From: Pederson Ronda M (AREVA NP INC) [Ronda.Pederson@areva.com]
Sent: Friday, August 14, 2009 5:23 PM
To: Tesfaye, Getachew
Cc: BENNETT Kathy A (OFR) (AREVA NP INC); DELANO Karen V (AREVA NP INC); VAN NOY Mark (EXT)
Subject: Response to U.S. EPR Design Certification Application RAI No. 201, FSAR Ch. 3, Supplement 1
Attachments: RAI 201 Supplement 1 Response US EPR DC.pdf

Request for Additional Information No. 201, Supplement 1, Revision 0

U.S. EPR Standard Design Certification

Question 03.07.02-35:

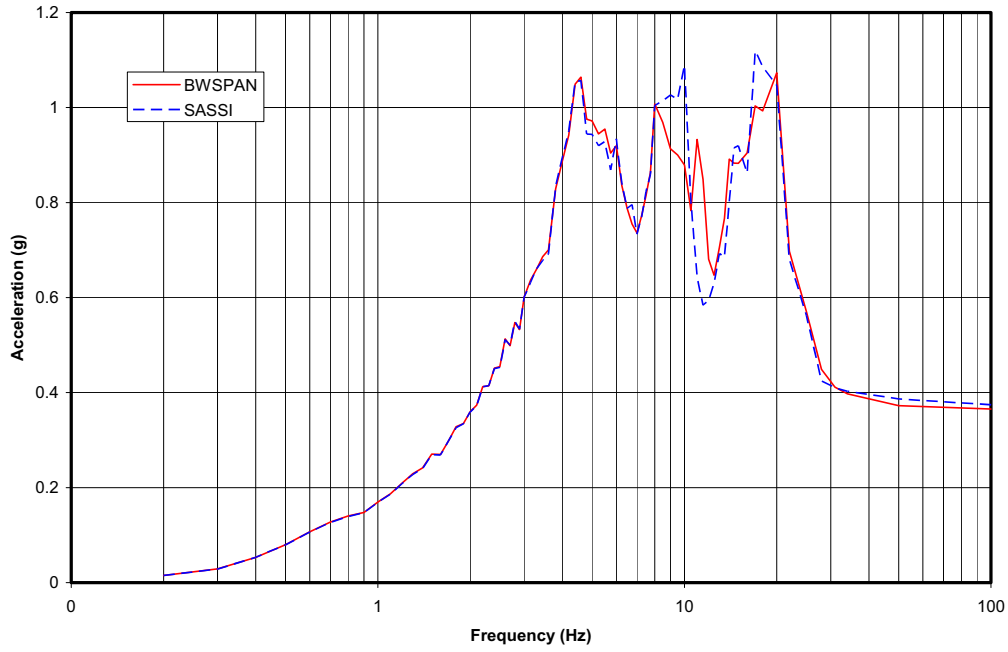
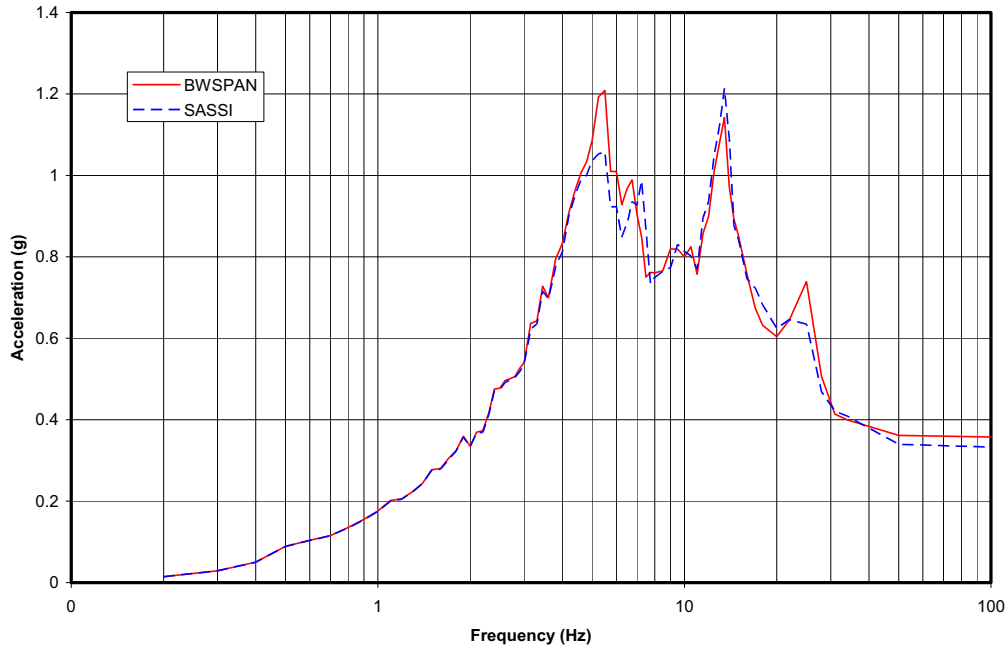
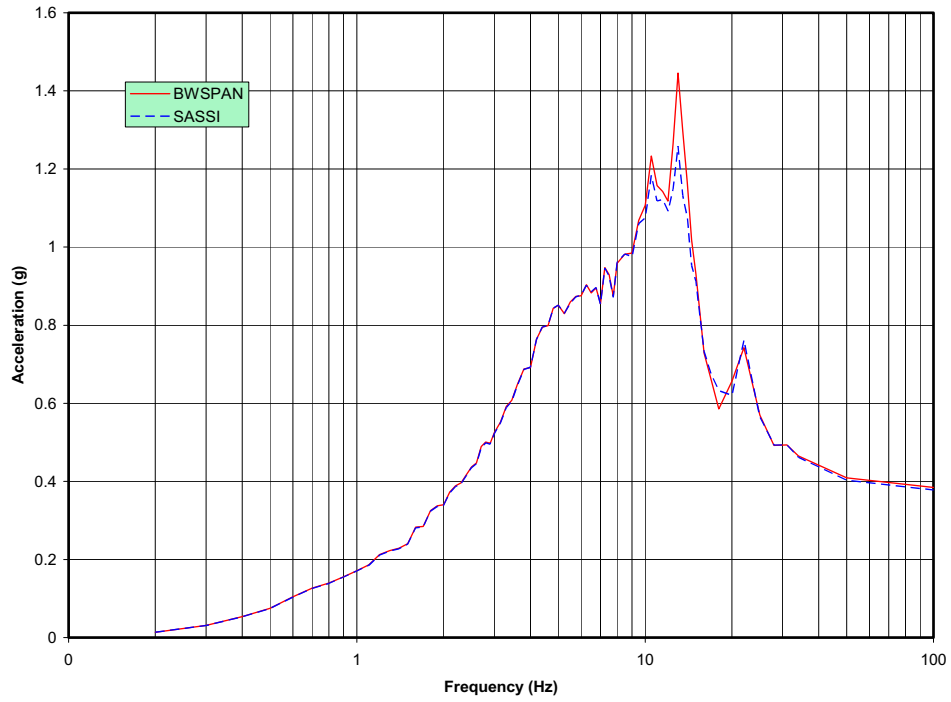
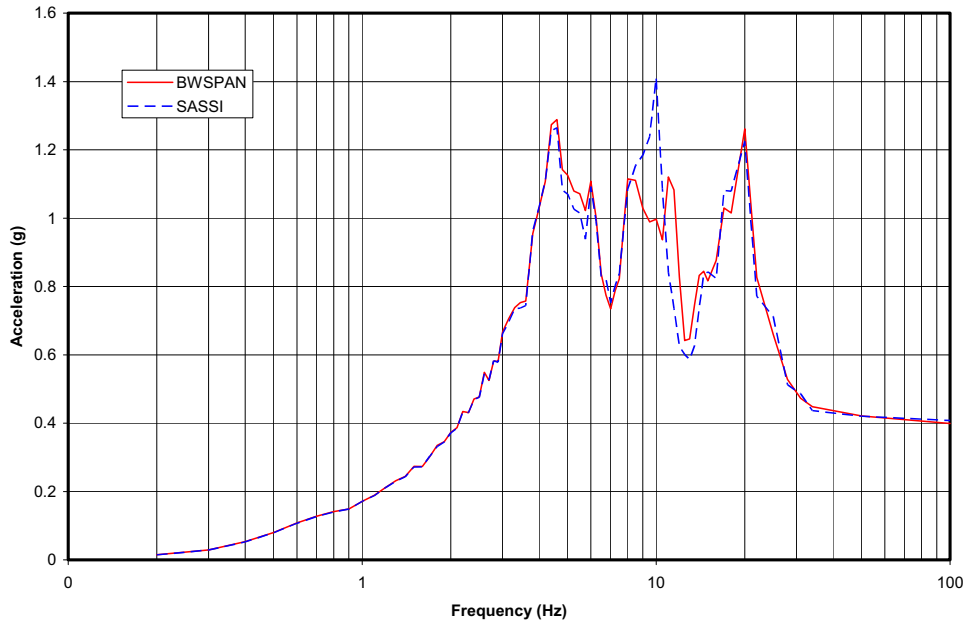
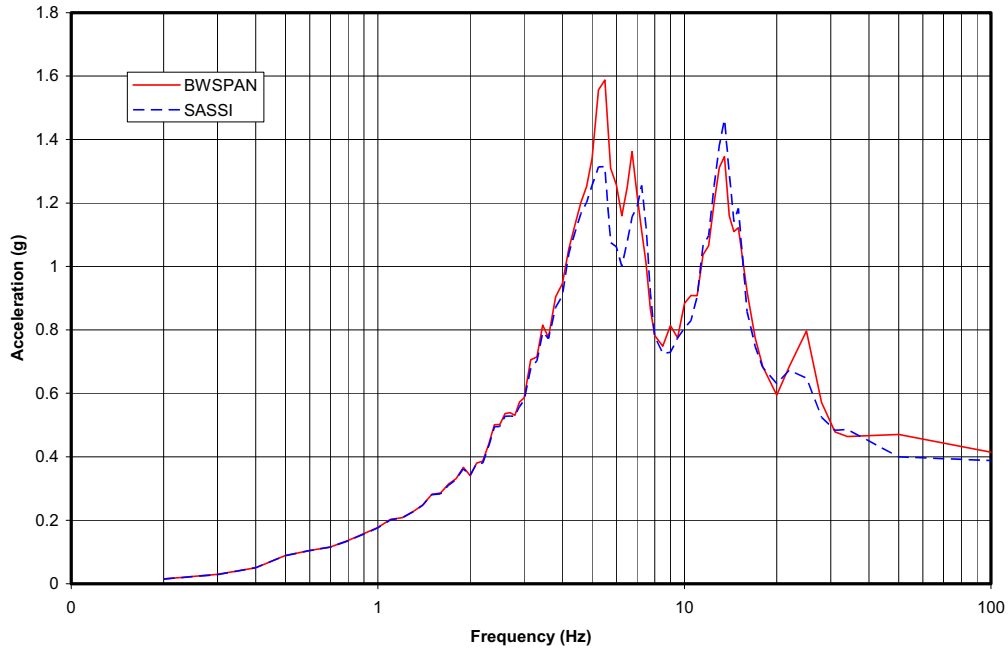
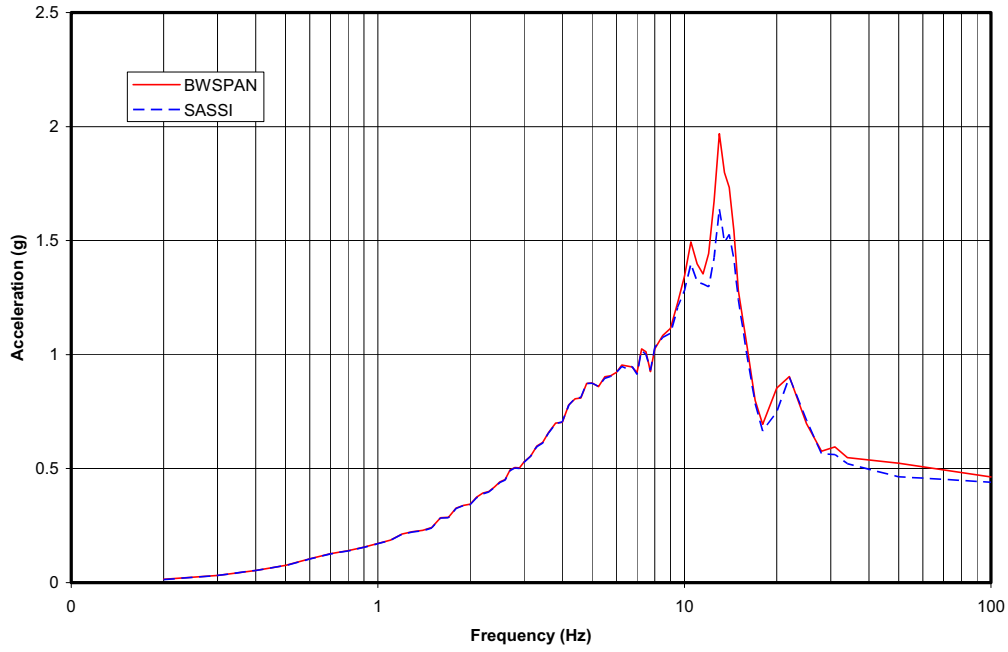
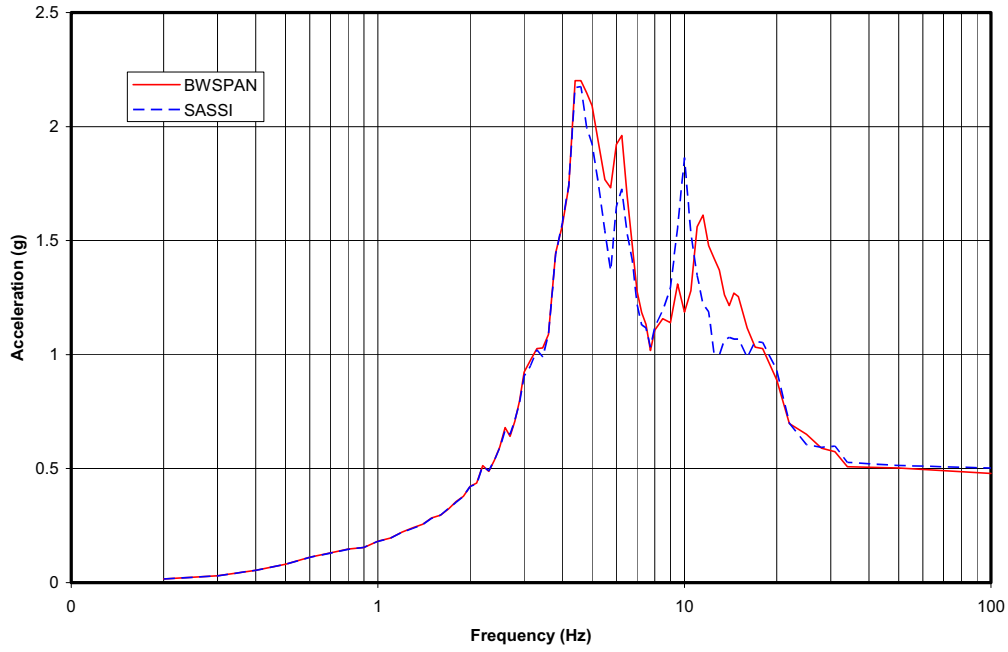
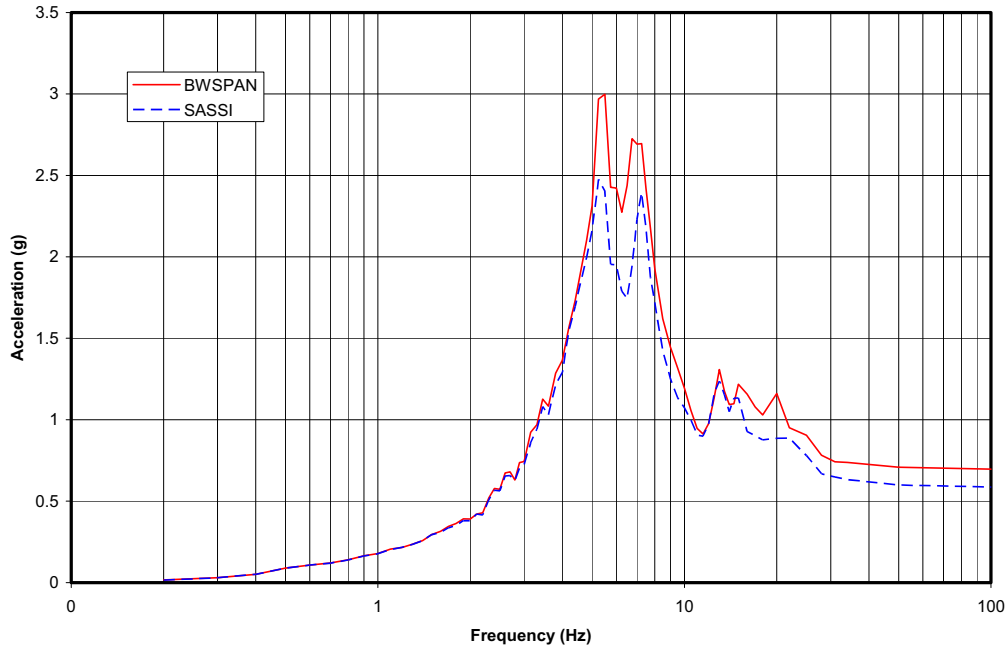
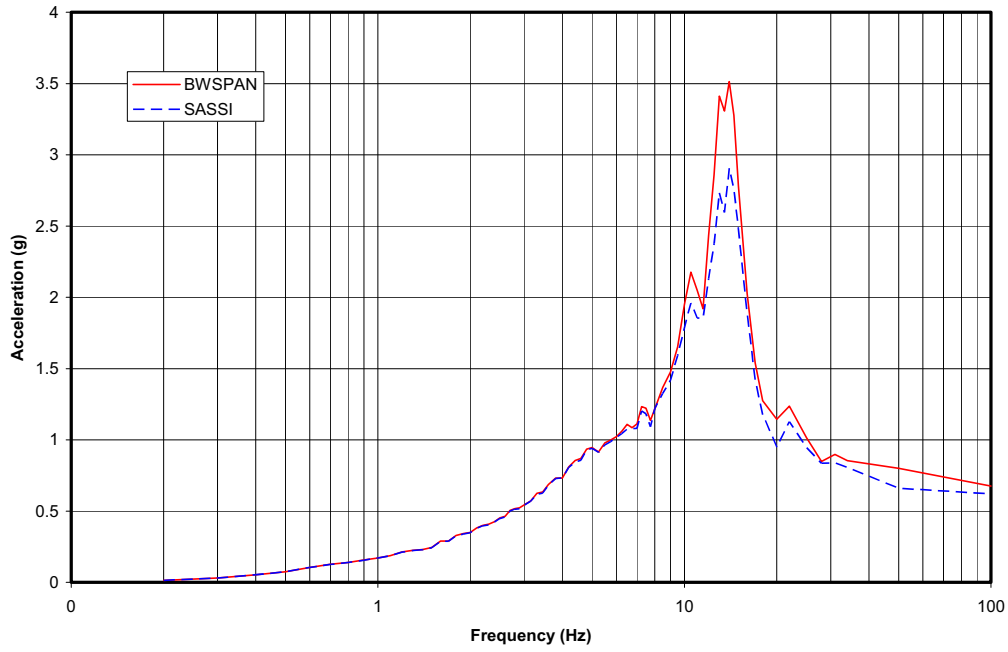
(Audit follow-up) Within the U.S. EPR standard design organization, one group is responsible for the seismic analysis of the NI common basemat structures and another group is responsible for the seismic analysis of the reactor coolant system (RCS). The NI seismic model contains a simplified model of the RCS provided by the group responsible for RCS seismic analysis. In a similar way, the seismic analysis of the RCS includes, in addition to a detailed model of the RCS, a seismic model of the Reactor Containment Building internal structure which supports the RCS. The seismic input for this coupled model consists of the time histories at the foundation mat determined from the NI seismic analysis. What are the methods used to verify that similar results are obtained in each of these analyses so as to verify that the interface forces are correct and that the coupled seismic model used in the analysis of the RCS is providing results consistent with the results obtained in the analysis of the NI common basemat structure? Include in your response a comparison of displacements and forces at key interface points of the RCS and internal structure from each of the models that document the adequacy of the results and methodology.

A simplified model of the RCS is included in the Reactor Building Internal Structure (RBIS) model to represent RCS effect on RBIS response in the soil-structure interaction (SSI) analysis. Likewise, to properly model building response in the RCS analysis, the RBIS model is coupled with the RCS model. Building seismic analysis is performed using the SASSI computer program and RCS analysis is performed using the BWSPAN computer program. The same RBIS model is used in both analyses but a simplified RCS model is used for building analysis.

Comparing acceleration response spectra generated at RCS support locations by these analyses shows that responses of the two models are similar. Figures 3.7.2-1 through 3.7.2-9 show X, Y, and Z comparisons for the reactor coolant pump (RCP) and lower steam generator supports, and the reactor pressure vessel supports and upper steam generator supports. The relationship of these support locations to the RCS model is shown in Figure 3.7.2-10.

Differences in spectra represent simplified versus detailed RCS models. These differences are minor and do not significantly affect design and qualification of components or piping.

Dynamic effects of RCS and RBIS are thus adequately modeled.
